3rd November 2016

Our Ref: 20586/cor/jo031116

RE: PLANNING REFERENCE 16 363

Figure 1 Measured Monthly Average Flows from the WTP to the Vartry River from 1988⁴ to 2016

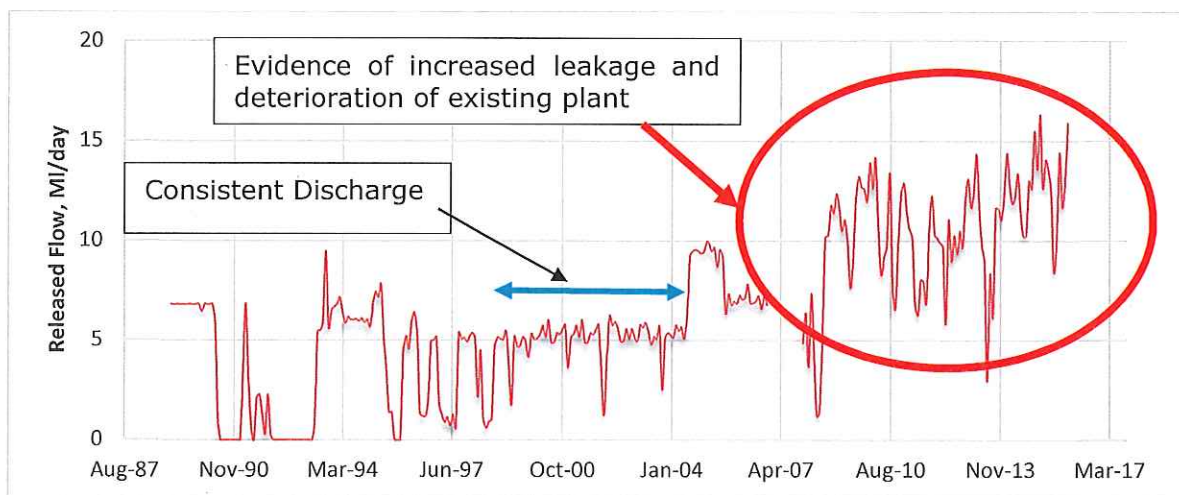
Clarification in relation to 1 (v) – "The flow graph provided indicates that the flow regime has been very variable historically with periods of no flow due to 'pumping back' and periods with higher flow (15ML/day) due to leakage. The current proposal, with leaks fixed, may result in protracted periods when a steady 5ML/day is discharged to the Vartry River due to no overflow from the reservoir during dryer months. Accordingly you may wish to comment as to the effect the change in flow regime with specific regard to the varied flow rates as opposed to relatively consistent flow rates will have on the downstream receiving environment with particular regard to meeting the objectives of the Water Framework Directive in responding to this item."

Consistent discharge rates were normal operating practice at the plant prior to 2008 as illustrated in Figure 1 below:

Variability in downstream flows occurred during spill events and from run-off from the downstream catchment both of which will not change as a result of this development.

Because there is an established practice of consistent discharge rates and because variability in flow has been provided by spill events and the downstream catchment, both of which will not be impacted by this development, there will not be a significant effect by returning the river to its 'normal' flow i.e. as it was from 1865 to when the plant started to fail in 2008, with the added benefit now of ensuring a minimum flow is always available.
